Planning Commission Agenda Memorandum

TITLE: Continued Public Hearing - 156 and 160 N. 12th Street
Major Site Plan Review

RE: This letter addresses the design modifications required by the commission at the hearing dated 4/29

A100
SITE PLAN
160 12TH STREET

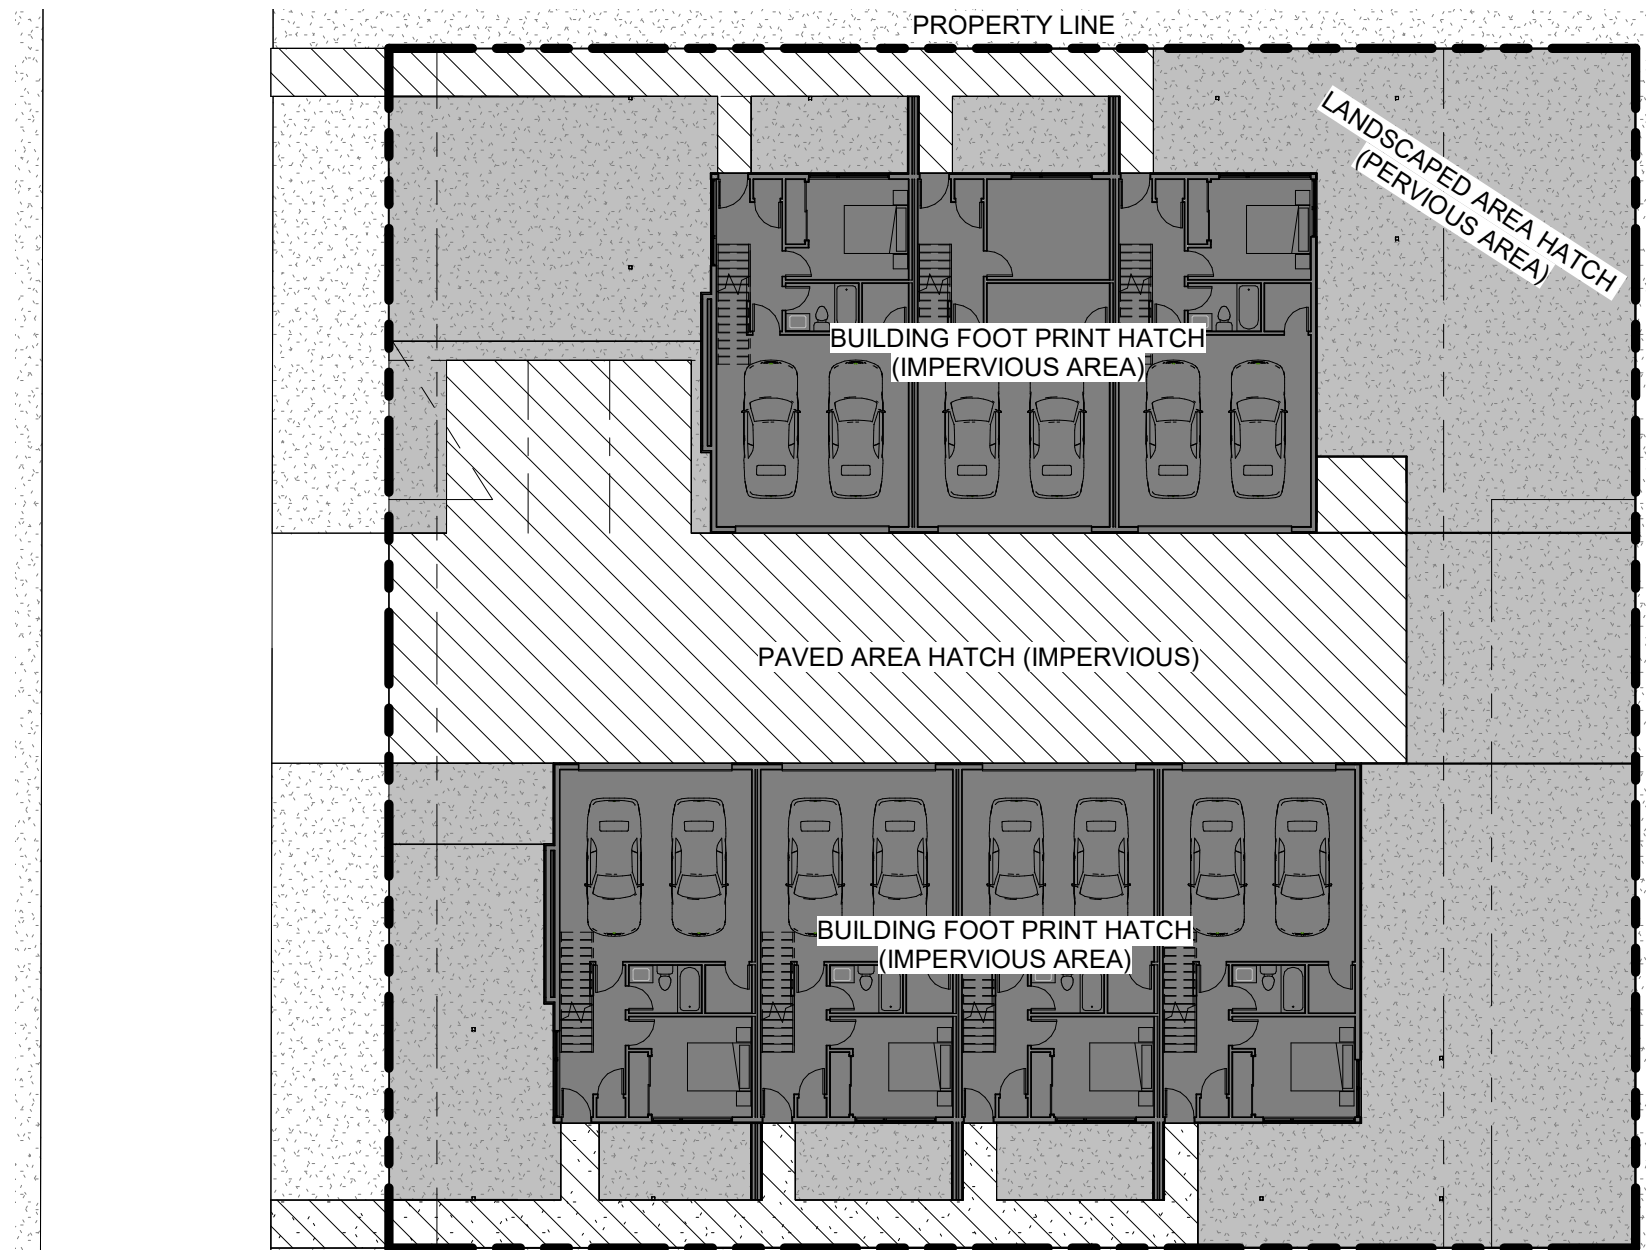
The deck on the east side of the southerly building was not in compliance with the 20 ft. rear yard setback as the deck extended 4.5 into the setback. The building was shifted to the west to bring the structure into compliance. The setbacks are now as follows:

2. The south building was moved to the west to remove the second level deck that was encroaching into the rear setback on the east side of the property. It is now in full compliance.

A101
MAIN LEVEL PLAN
160 12TH STREET

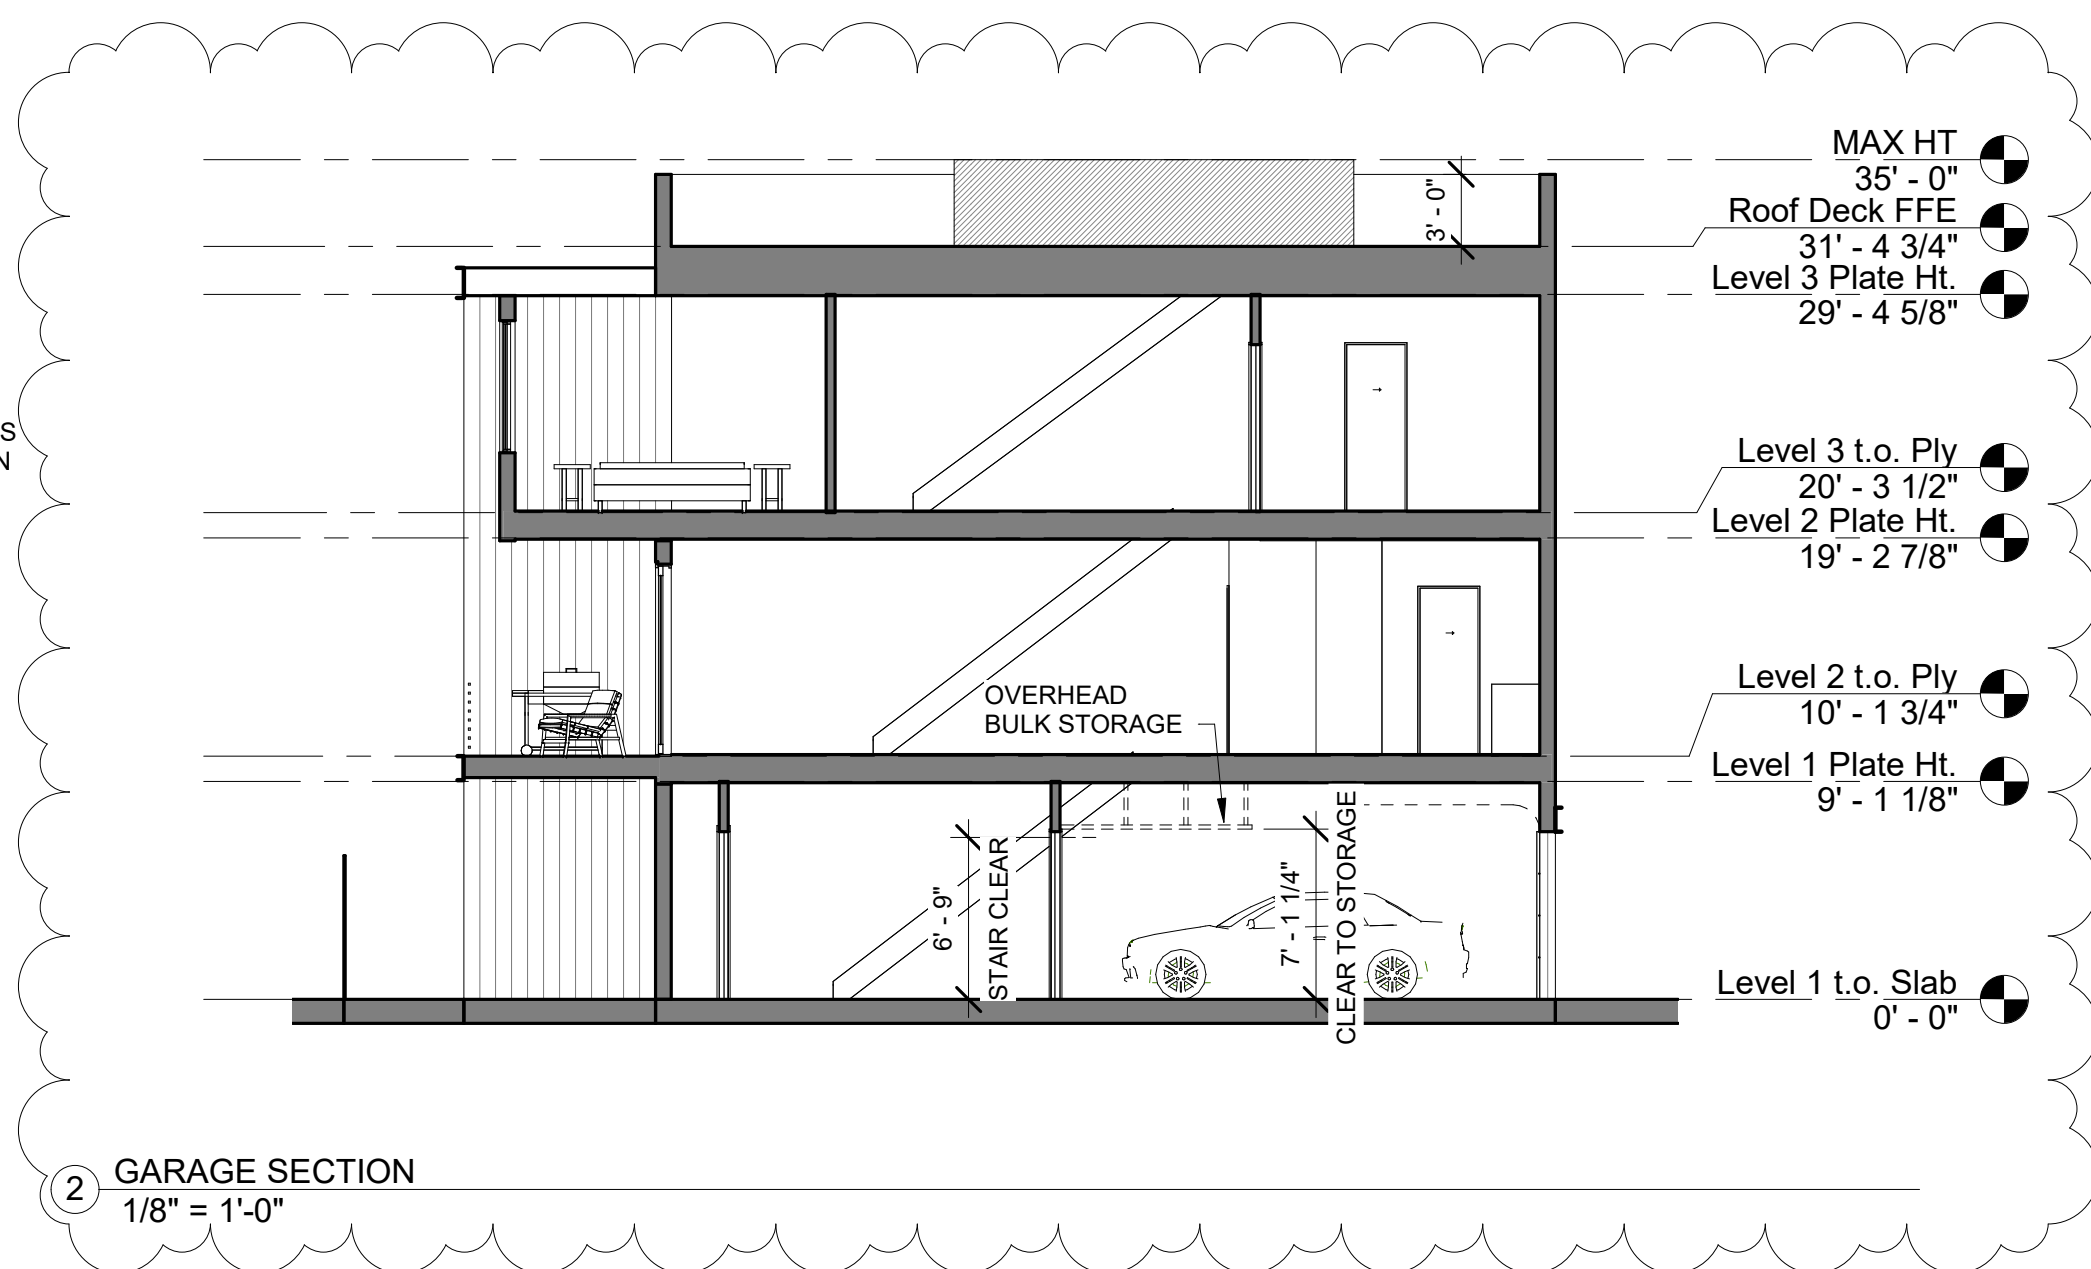
The letter and revised plans (Sheet A101) indicate that additional overhead bulk storage was added in the garage. The calculations on the amount of cubic feet of storage now provided in the garage was not included in the revised material. The applicant should be prepared to provide that information at the meeting.

Staff had asked that a cross-section should be submitted to demonstrate that the 20 ft. by 20 ft. parking area in the garage is unencumbered by the stairway. Sheet A101 has been revised to include a cross section showing the stairway does not impede the parking spaces.

3. The trash enclosure will be enclosed and clad with materials to complement the overall building site design.
4. Additional overhead bulk storage was added to garage units to satisfy more need for bulk storage on the main level. Each unit will receive these additional storage areas.

A202
BUILDING ELEVATIONS
160 12TH STREET

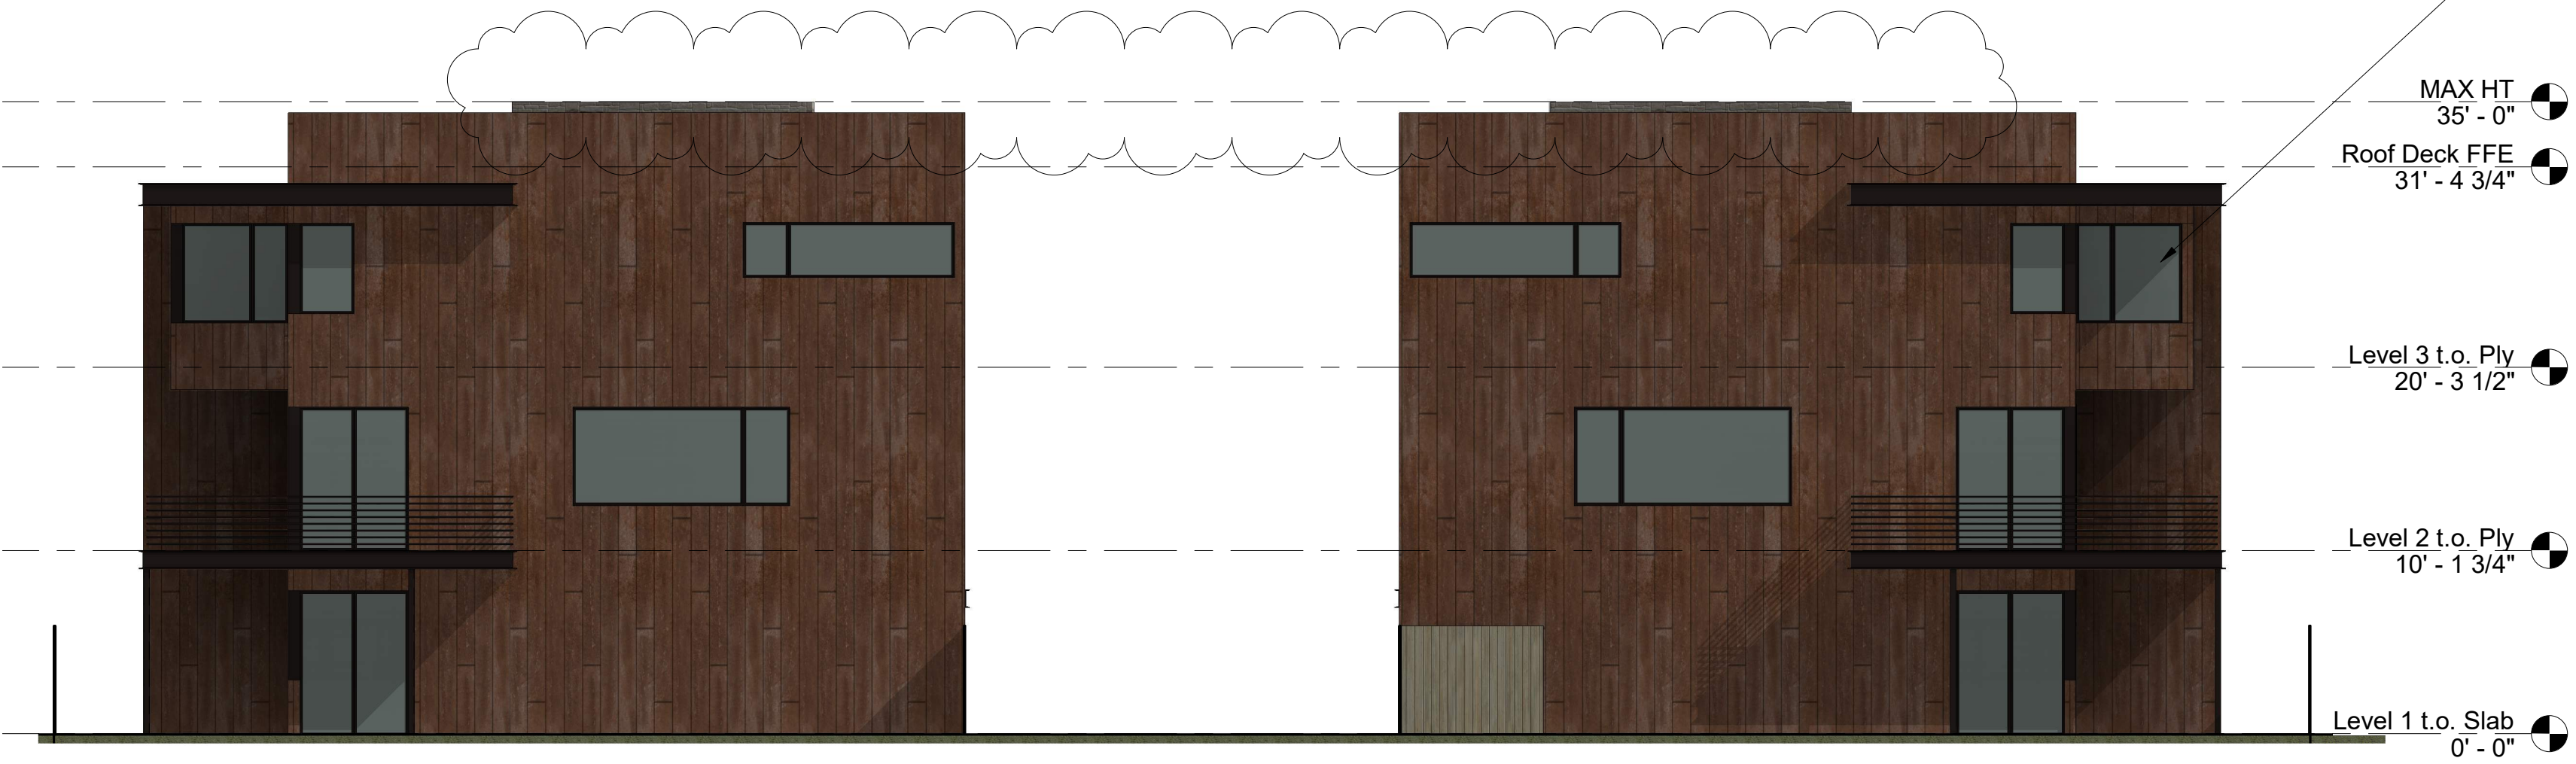
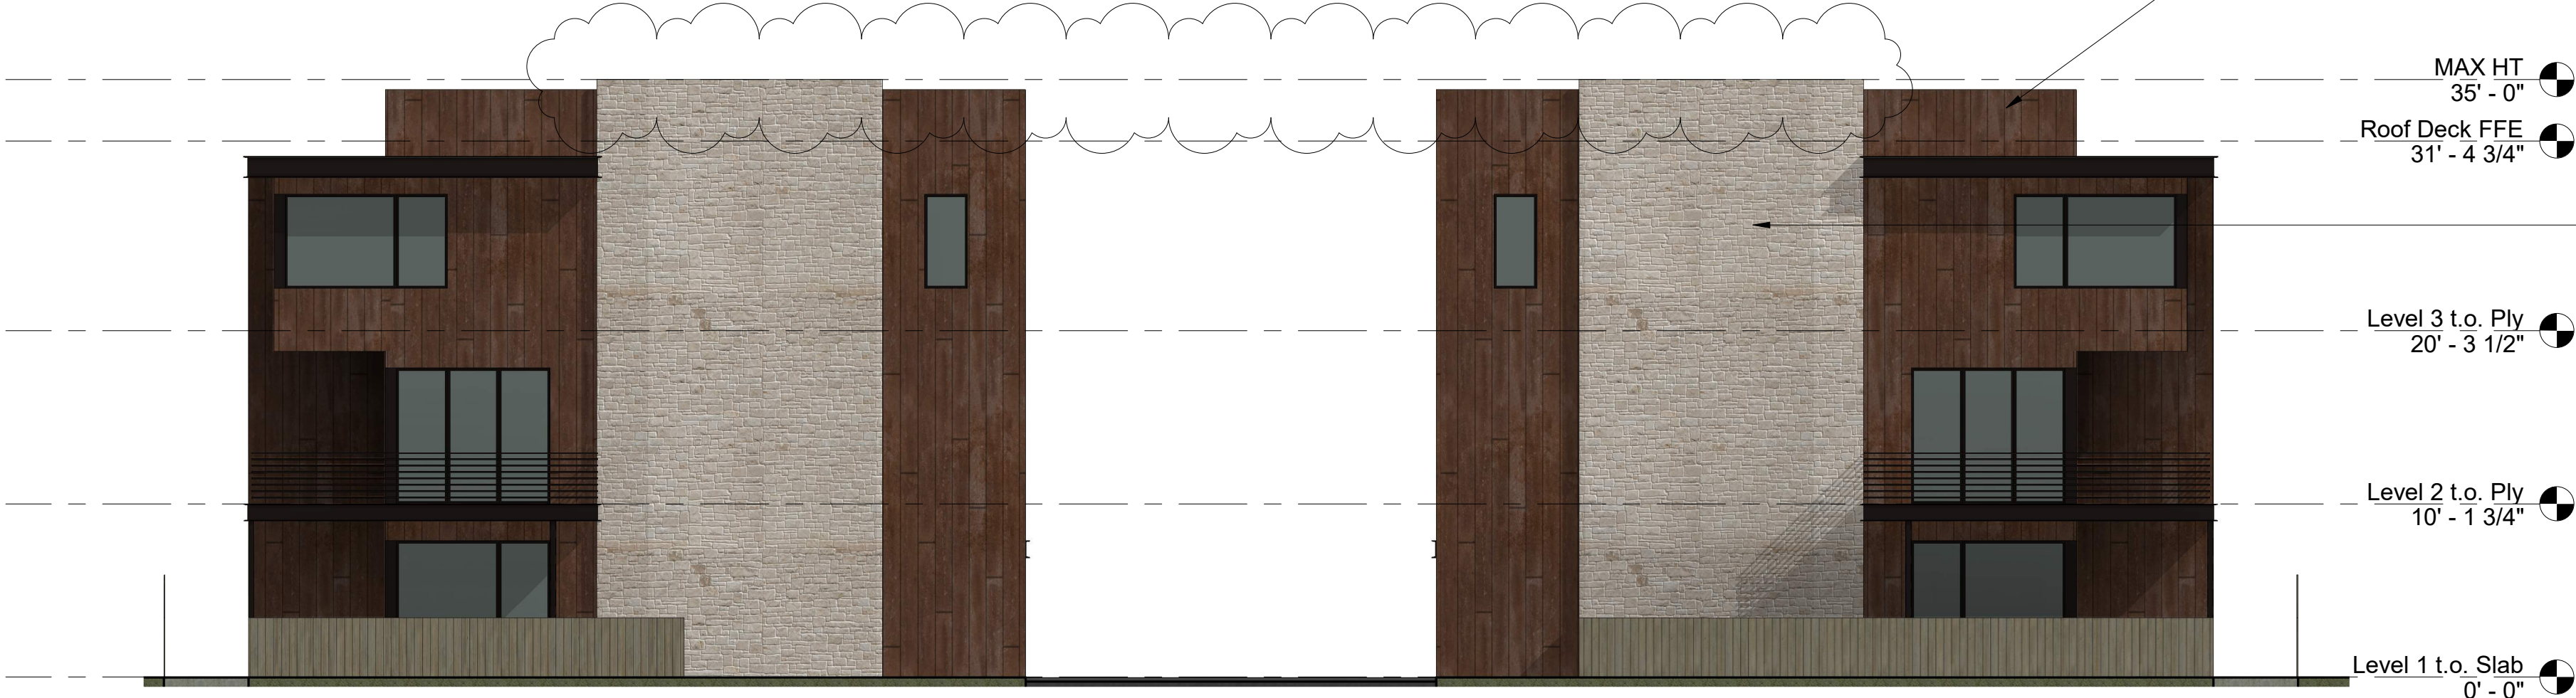
The building elevations were revised to lower the stone veneer section of the building on the west side to comply with the 35 ft. height limitation.

1. As requested we have abandoned the rooftop access via an enclosed stairway that exceeded the maximum allowable building height. We have lowered the stone mass to be in compliance with the maximum building height of 35 ft as per the UDC.
